# Stair flip study · the main stair turned round: start and arrival at the NORTH end, next to the lift · Taif / Palm House V8.0 (work) · STUDY ONLY

**ADOPTED 2 Nov 2026 (owner): option B, the freed landing as F-b, the balustrade, the store door onto the riwaq, the half-landing window, the entrance side light, the entry cupboard removed; applied to the design files.** Owner's idea, 1 Nov 2026 · the same well (2.75 × 5.7 on axes, 2.525 × 5.50 clear), the same 22 risers × 0.164 / goings 0.28, flights 1.21 clear · nothing in the design files changes until the owner decides · all sizes assumed

## 1 · The two options on the ground floor

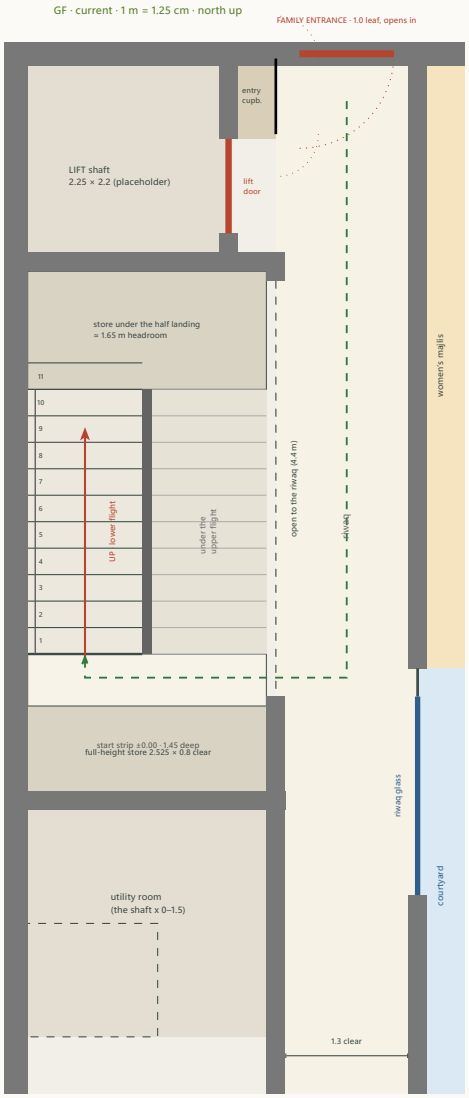
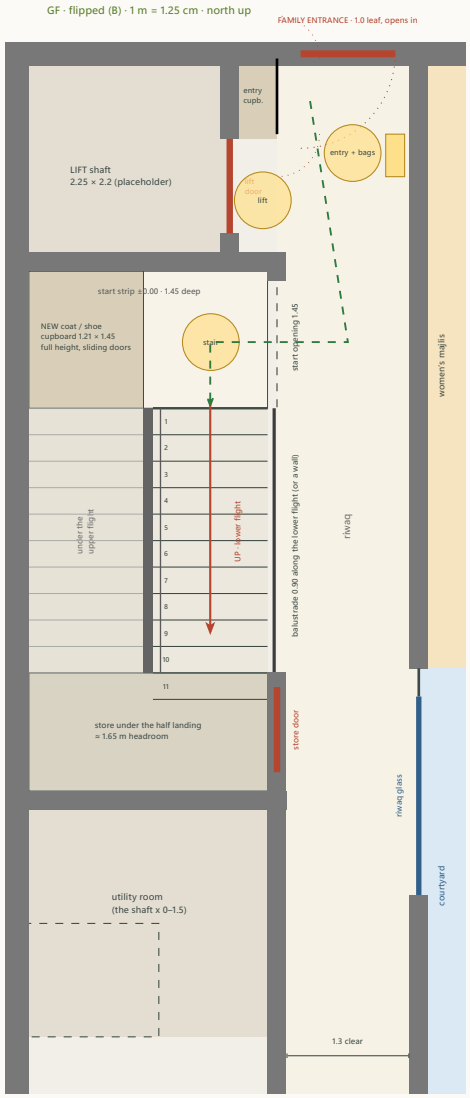
- **Current:** the lower flight on the **west** half starts at the **south** end (first riser y 6.35); the person comes along the riwaq, enters the well through its open east side (4.4 m open) and turns west onto the flight; in front of the first riser only **0.55 m** before the full-height store's wall (the start is really made from the side, under the upper flight's high end). Half landing at the north end (+1.80, a 1.65 m store below it, opening east onto the riwaq); the full-height store 2.525 × 0.8 clear at the south end.

- **Flipped (B, recommended of the two flips):** the lower flight on the **east** half starts at the **north** end (first riser y 3.75), **straight off the lobby**: a 1.45 m opening in the x 2.75 line between the lift notch and the flight, a start strip 1.45 m deep in front of the first riser. The lower flight rises along the riwaq side (a 0.90 balustrade on the riwaq, or a wall: the owner's choice); the half landing at the south end with its 1.65 m store (door onto the riwaq at y 6.7–7.6, in front of the courtyard glass; or into the utility room). The **west half of the start strip** (1.21 × 1.45, full height) becomes a **coat / shoe cupboard** beside the family entrance (sliding doors onto the strip).

- **Flipped (A):** the mirror image only (the lower flight stays west): the person crosses the whole strip to the far half before climbing; no cupboard. Not recommended; everything else below holds for both.

## 2 · Congestion test at the flipped start (drawn)

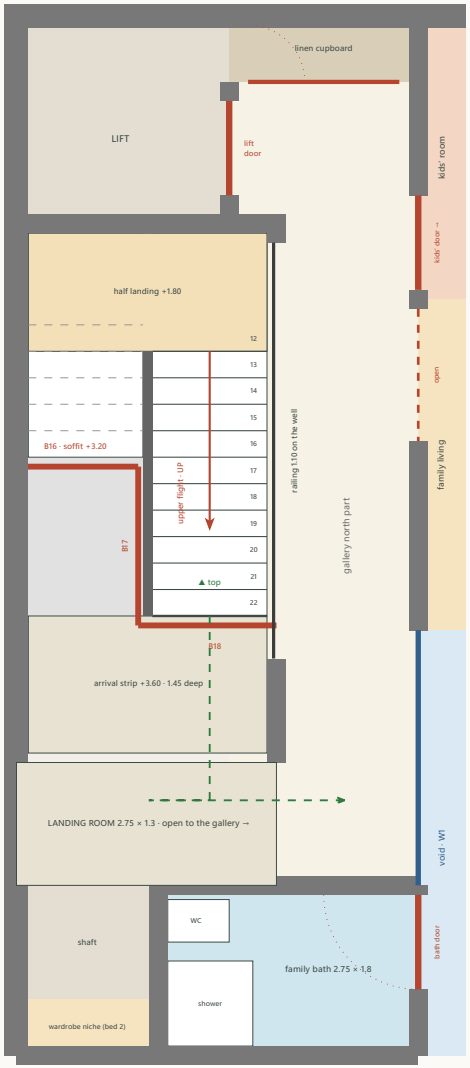
Three people at once: **one waiting for the lift** in the 0.50 m notch in front of its sliding door, **one coming in with bags** inside the family entrance's 1.0 m swing, **one starting up the stair** on the start strip, with the **entry cupboard's two 0.45 leaves open** into the lobby. Clear widths, not axes: the lobby **1.3 m** between the lift / cupboard wall face and the women's majlis wall face (the notch adds 0.5 m at y 0.9–2.2); the start opening **1.45 m**; the first riser **1.21 m** wide; the entrance **0.9 m** clear. The three stand in three separate zones along the lobby (y 0–1.0 the door swing, y 0.9–2.2 the lift notch, y 2.3–3.75 the start strip); the stair starter passes 0.3 m south of the lift waiter and never crosses the entrance swing: **OK**. Two people can pass in the 1.30 m lobby (0.60 + 0.60 + 0.10) but a person with two bags blocks it for a moment, as today. **Furniture up the stair:** the 90° turn from the 1.30 lobby through the 1.45 opening onto the 1.21 flight is a tight but normal house stair turn; the current start (0.55 m strip, sideways) is worse.

# First floor · the arrival, the opening and its trimmers, the freed landing · current vs flipped

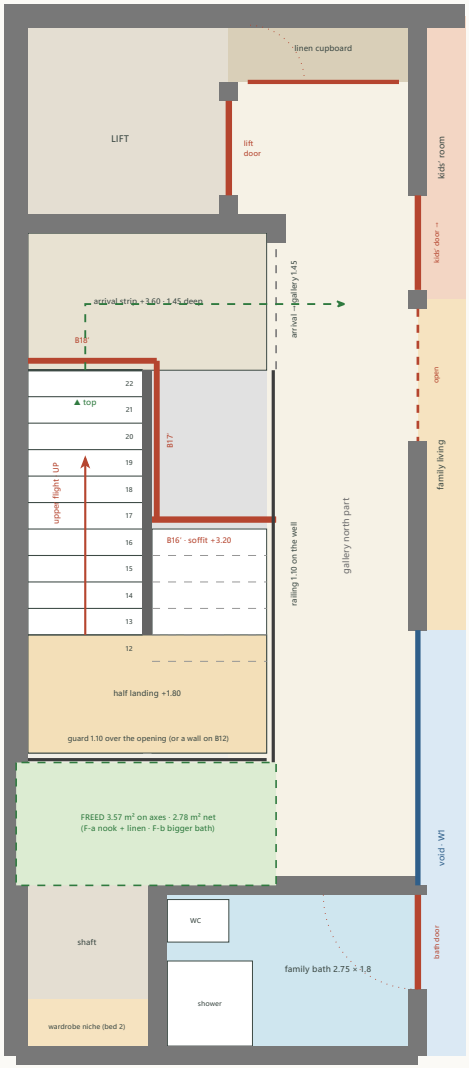
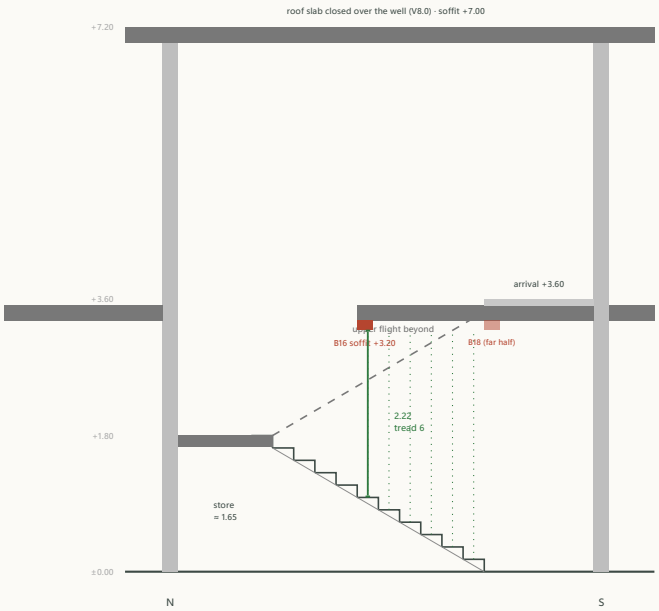
- **Current:** the upper flight (east half) lands at +3.60 on the arrival strip (y 6.35–7.8), then the **landing room** (2.75 × 1.3, y 7.9–9.2) and east into the gallery; the bedrooms and the family bath are at hand, the kids' room, the living and the lift are 6–9 m north along the gallery.

- **Flipped (B):** the upper flight (west half) lands on the arrival strip at the **north** end (y 2.3–3.75); the strip opens east onto the gallery's north part (1.45 m), **0.10 m south of the lift notch**: the lift's first-floor door, the linen cupboard (its leaves swing south, 0.6 m), the kids' room door (opens into the room) and the family living's opening are all within 1–3 m. The gallery's north part (1.30 clear) carries the arrival traffic as it carries the lift's today; the linen leaves and the lift door are 1.0 m north of the arrival: no clash. The railing on the well runs from the arrival (y 3.75) to the south wall; the landing room is **freed** (§ 5).

- **Current (studies/structure.typ):** an L-shaped opening ≈ 8.2 m²: the west half open from the north wall to B16 (y 4.85), the east half open to B18 (y 6.45); B16 (0.20 × 0.40, soffit +3.20) from the west wall to B17; B17 (x 1.29, on the lower flight's side of the split) from B16 to B18; B18 (y 6.45) from B17 to the riwaq-line beam B10 (x 2.75).

- **Flipped (B):** the **same opening turned round** (≈ 8.2 m²): the east half open from B16′ (y 5.33) to the south wall, the west half from B18′ (y 3.65) to the south wall. **B16′** (y 5.33) from the riwaq-line beam B10 to B17′; **B17′** (x 1.49, on the east, lower flight's side of the split: never over the upper flight) from B16′ to B18′; **B18′** (y 3.65, the arrival edge) from the west wall to B17′. The same zigzag, mirrored: one beam-on-beam junction at each end of B17′, the torsion the engineer's; B18′ now bears on the west wall (as B16 does today) and B16′ on B10 (as B18 does today). **Neither better nor worse** for the structure: the spans (1.3–1.6 m) and the bearings are the same kind. **Not verified.**

- **Slab edges:** the arrival strip (1.45 × 2.525) spans between the north wall beam B11 (y 2.2) and B18′; over the lower flight's first six treads the slab spans from B18′ to B16′ (1.6 m) between B10 and B17′. The guard round the opening: the railing on x 2.75 from the arrival south to y 7.9, the well's south wall line y 7.9 (a 1.10 guard or a wall on B12), the upper flight's balustrade on the split.

# Headroom · a section along the lower flight for each option · the slab 0.2 thick (soffit +3.32), the trimmers 0.20 × 0.4 (soffit +3.20), the finish 0.08 · over the full walking width of every tread

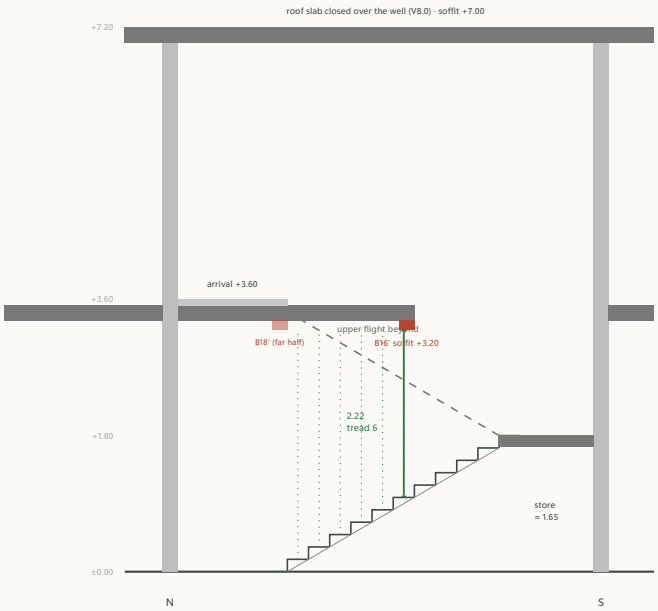
The upper flight, the half landing and the arrival are under the open well (the roof slab's soffit +7.00): ≥ 3.4 m. Minimum of this option: **2.22 m** at tread 6 under the trimmer, across the whole 1.21 m width (the trimmer spans the half); B17 over the inner 0.10 strip of treads 1–5: ≥ 2.38 m.

The upper flight, the half landing and the arrival are under the open well (the roof slab's soffit +7.00): ≥ 3.4 m. Minimum of this option: **2.22 m** at tread 6 under the trimmer, across the whole 1.21 m width (the trimmer spans the half); B17′ over the inner 0.10 strip of treads 1–5: ≥ 2.38 m.

**Verdict on the headroom:** identical in both options (**2.22 m** at tread 6 under the trimmer, 2.83 m at tread 3 under the slab; ≥ 2.10 required, the 2.20 aim just met) because the flip mirrors the geometry: the trimmers sit in the same places relative to the treads. **The flip neither improves nor worsens the trimmers.** What would improve both: trimmers 0.20 × **0.30** (soffit +3.30 → **2.32 m** at tread 6) if the engineer accepts a 0.30 depth for the 1.3–1.6 m spans, or the slab edge moved one tread (the opening 0.28 m longer, ≈ 0.35 m² more void, tread 6 under open sky → the minimum moves to tread 5: 2.38 m). Both options can take either. The walls' handrails run the full flights (0.08 off the walls); the central handrail on the 0.10 split.
